ADDENDUM

Project:	Arlington Woods Free Methodist Church Renovation	Post Tender Addendum No.:	A04
Tender #	N/A	No. of Pages:	10 (including cover page)
Project #	1846	Date:	January 07, 2021

Item No.	Drawing or Spec Section	Description
PT-A4.1 General		
PT-A4.1.1	PTM1	Post-Tender Mechanical Addendum PTM1: Refer to the attached PTM1 for new mechanical provisions to add cooling to Kitchen 110. Mount AC-1 unit above existing upper cabinets on east wall of Kitchen 110. Optional location for placement of exterior condensing unit on roof above Kitchen 110 area. Provide precast concrete pavers on 50mm rigid insulation anchored into roof system. Seismically-restrain slab & unit to building structure.
PT-A4.1.2	PTE1	Post Tender Electrical Addendum PTE1: Refer to the attached PTE1 for electrical provisions to supplement new cooling system in Kitchen 110 per PTM1.

ARLINGTON WOODS FREE METHODIST CHURCH RENOVATION

MECHANICAL SPECIFICATIONS, SCHEDULES & DETAILS

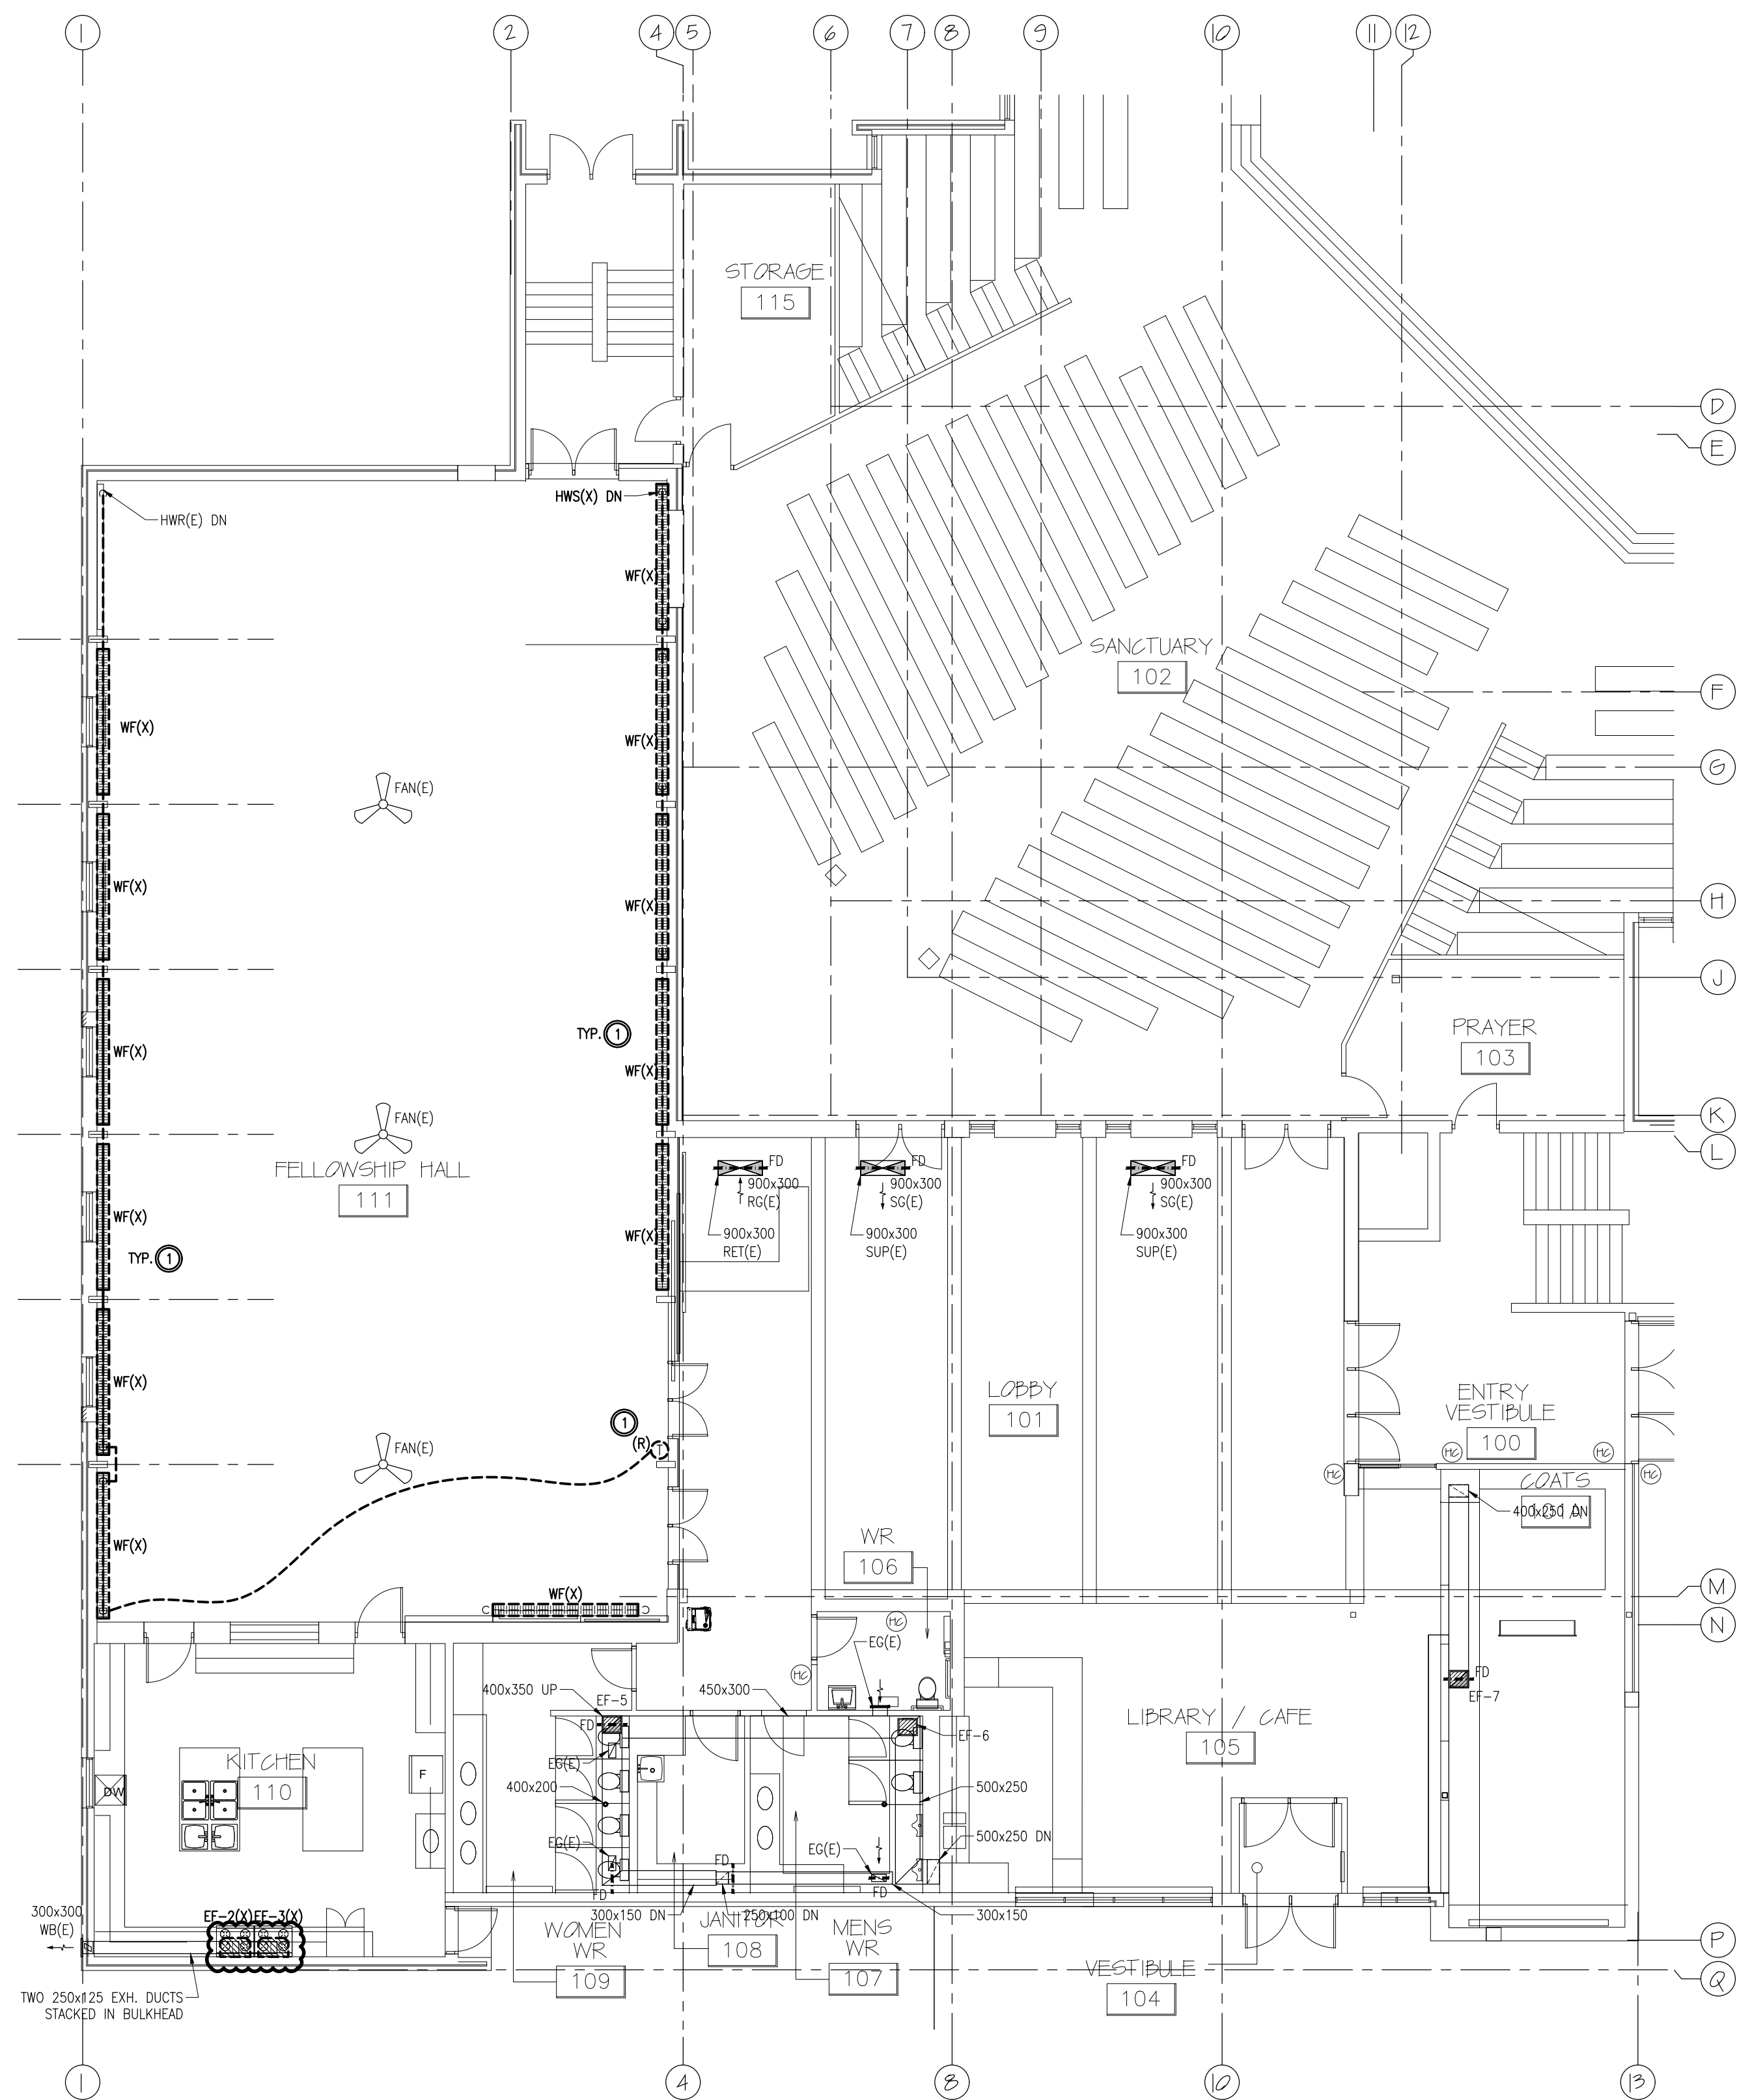
1. Reference Attached Revised Drawing M2:

- .1 RTU and ductworks details have been relocated from Drawing M2 to Drawing M1.
- .2 Sections "25. Wall mounted ductless split" and "26. Refrigerant piping" added to specifications.
- .3 Ductless split unit and condenser unit schedules added to drawing.

25. WALL MOUNTED DUCTLESS SPLIT:

1. GENERAL:
 1. INTEGRATED PACKAGE: TO CAN/CSA C656.
 2. SYSTEM TYPE:
 1. AIR FLOW ARRANGEMENT: WALL MOUNTED CASSETTE.
 2. COOLING: DIRECT EXPANSION WITH MATCHING AIR COOLED CONDENSING UNIT.

3. UNIT CAPACITY: REFER TO EQUIPMENT SCHEDULE.
 4. UNIT CAPACITY: TO BE SIZED USING INDOOR AIR AT 22°C AND 50% RH & OUTDOOR AIR AT 35°C.
 5. CAPABLE OF OPERATING WITH A REFRIGERANT PIPING LENGTH OF 20 METERS (65 FT.).

6. UNIT TO BE EQUIPPED WITH UNIT MOUNTED CONDENSATE PUMP.
 7. ACCEPTABLE MATERIALS: MITSUBISHI OR APPROVED EQUIVALENT BY ADDENDUM.
2. CABINET:
 1. GALVANIZE STEEL FRAME, EPOXY COATED FINISH. READY FOR CEILING MOUNTING COMPLETE WITH WHITE PLASTIC COVER.

**MECHANICAL
GROUND FLOOR
HVAC AND UTILITIES
REMOVALS & NEW WORK**

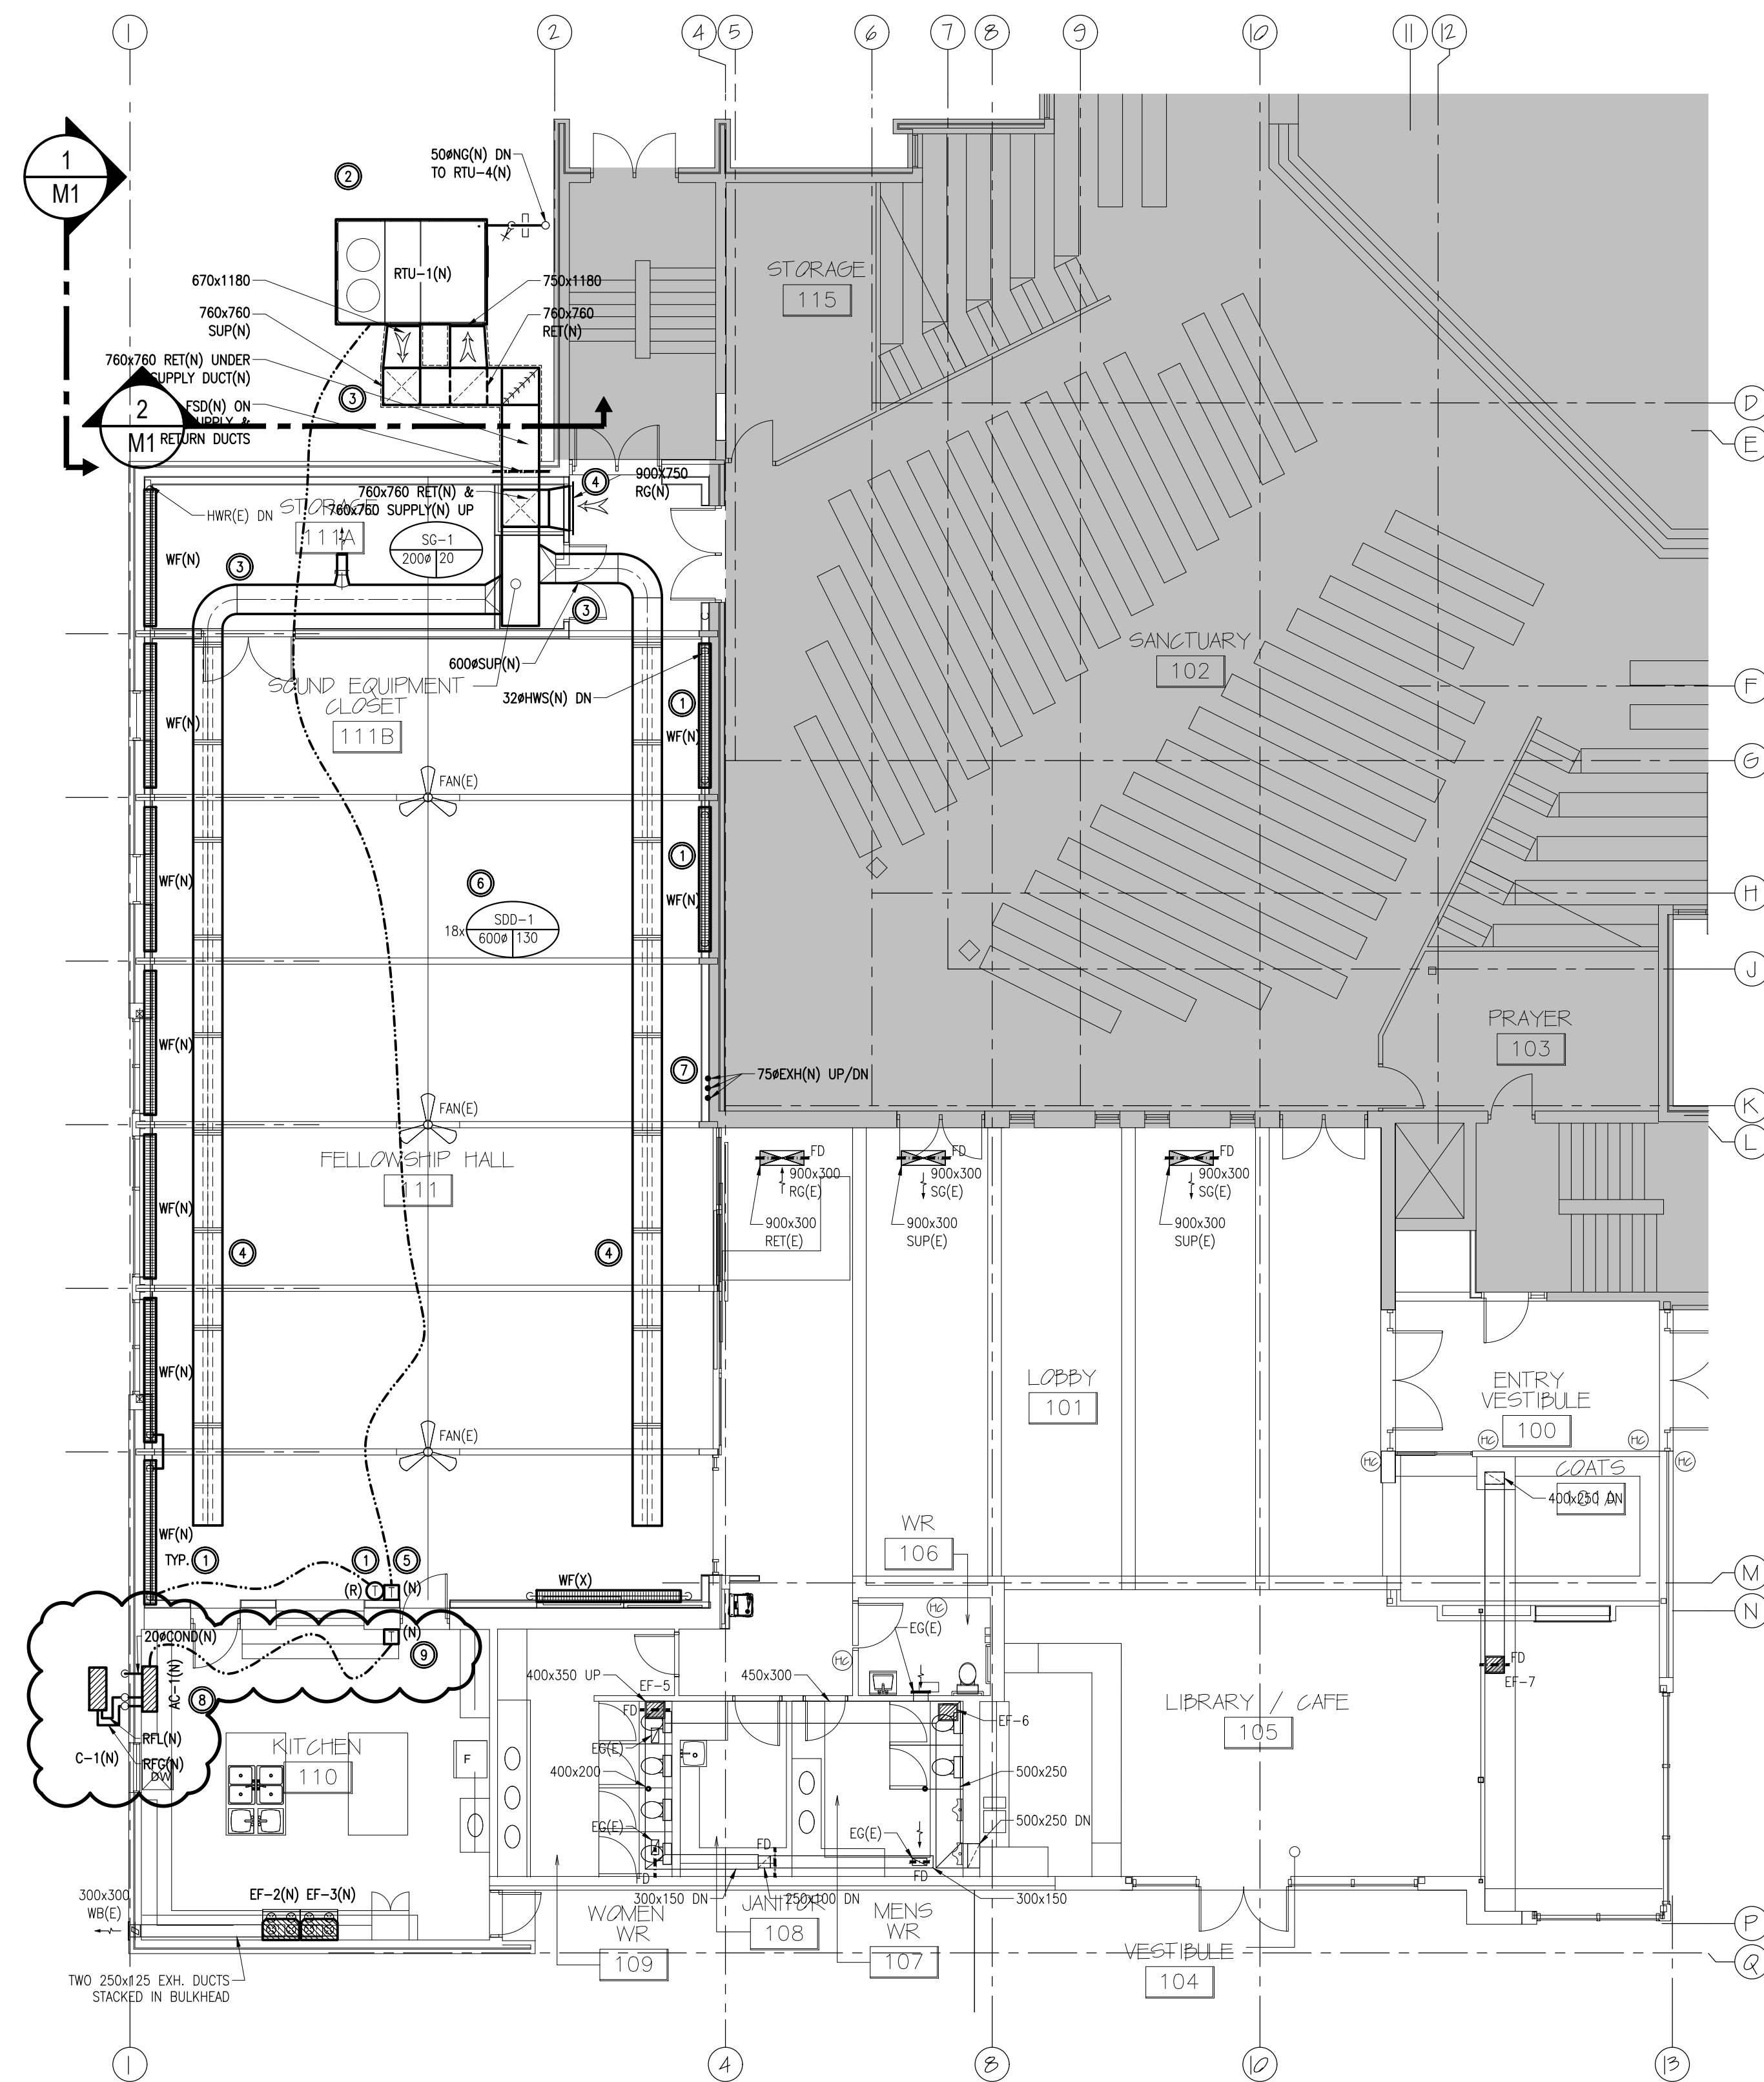
1. Reference Attached Revised Drawing M5:

- .1 Contractor to provide new wall mounted ductless split unit and condenser unit c/w refrigerant piping and accessories.
- .2 Contractor to provide new thermostat c/w accessories and wiring. Refer to detail 3/M1 for complete control scope of work.

- PROVIDE NEW WALL MOUNTED DUCTLESS SPLIT UNIT & NEW CONDENSER UNIT C/W ASSOCIATED ACCESSORIES.
- PROVIDE NEW THERMOSTAT C/W ASSOCIATED ACCESSORIES AND WIRING. REFER TO DETAILS 3/M1 FOR COMPLETE SCOPE OF WORK.

Drawing titre/Titre du dessin
ELECTRICAL DRAWING LIST, LEGENDS & LIGHTING FIXTURES SCHEDULE

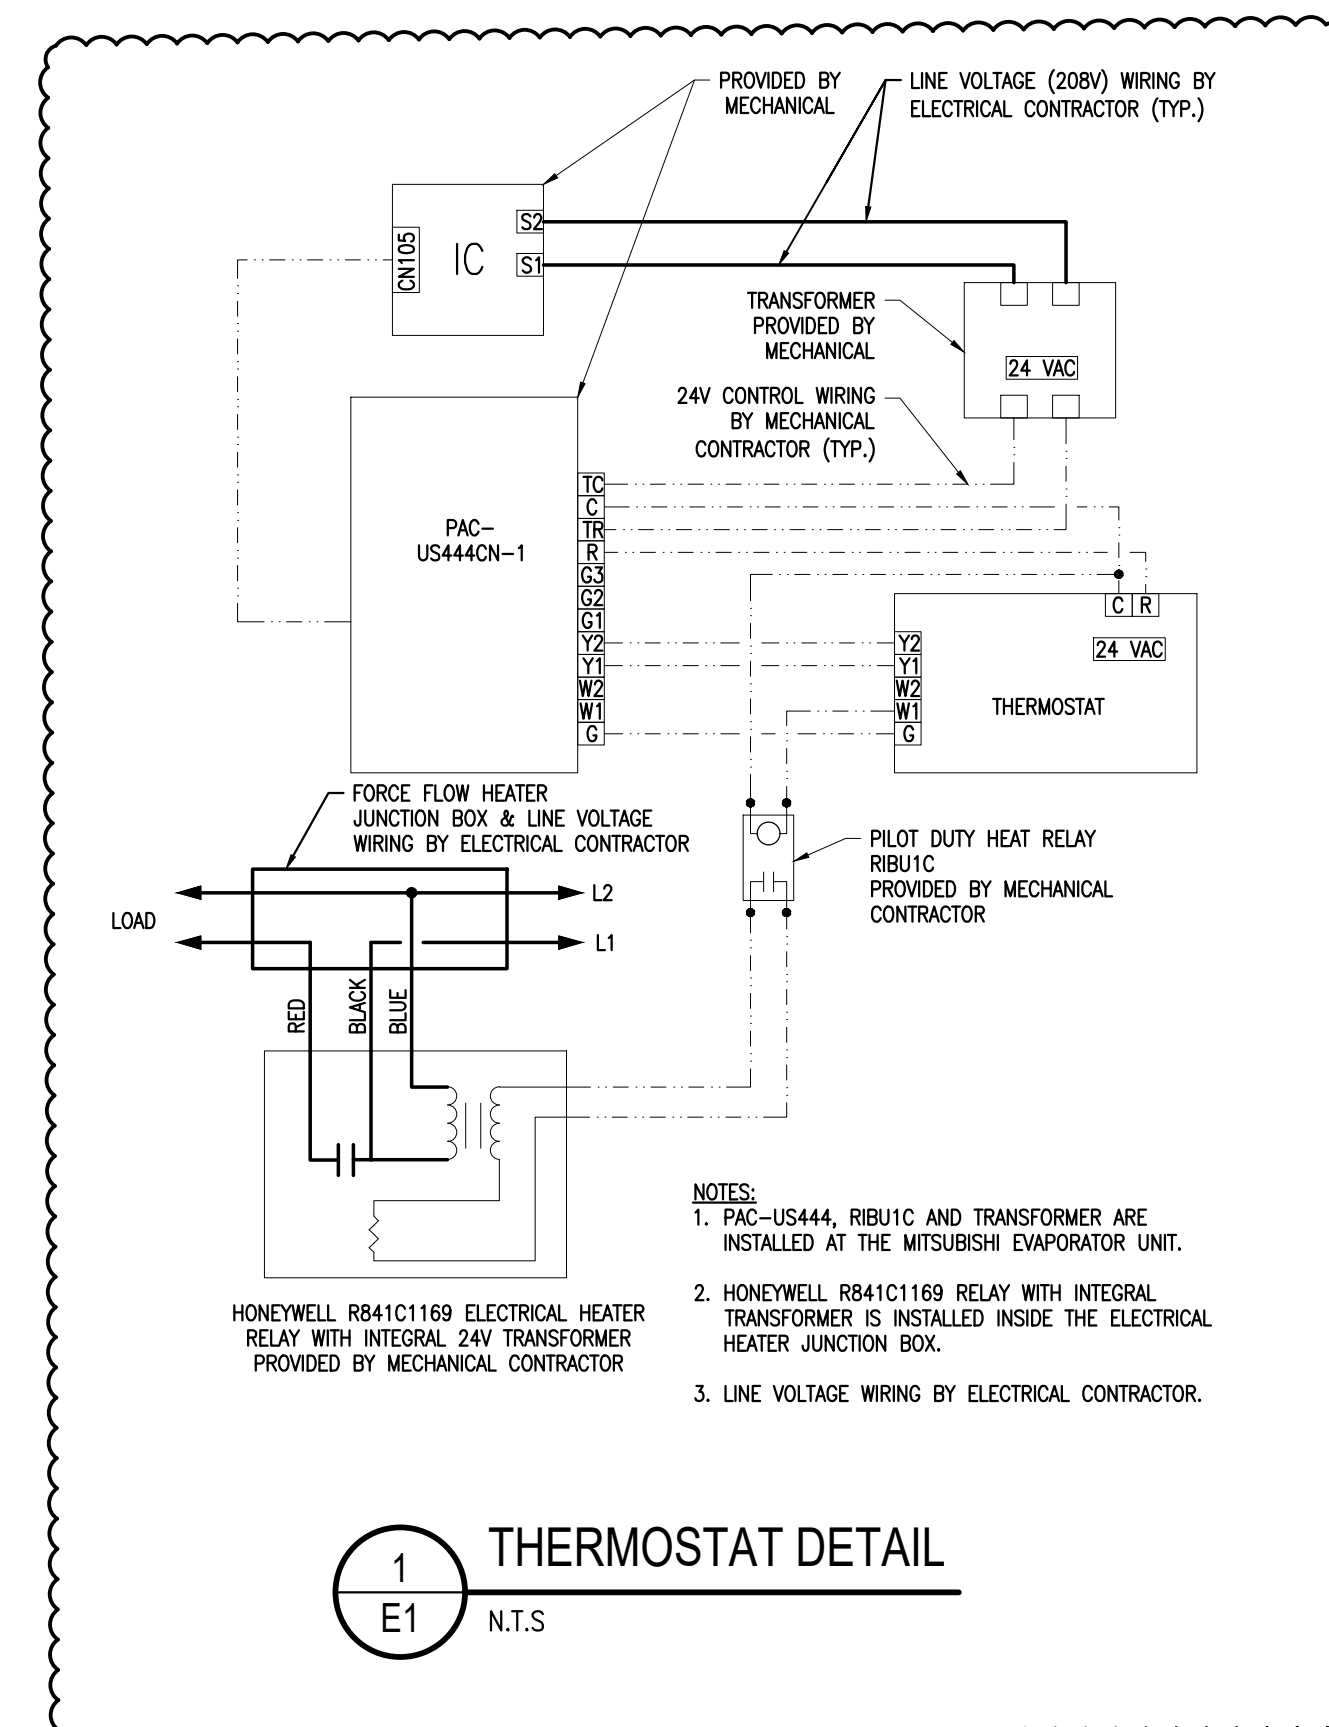
1. Reference Attached Revised Drawing E1:

- .1 Add Thermostat detail 1/E1 as indicated on attached revised Drawing E1.
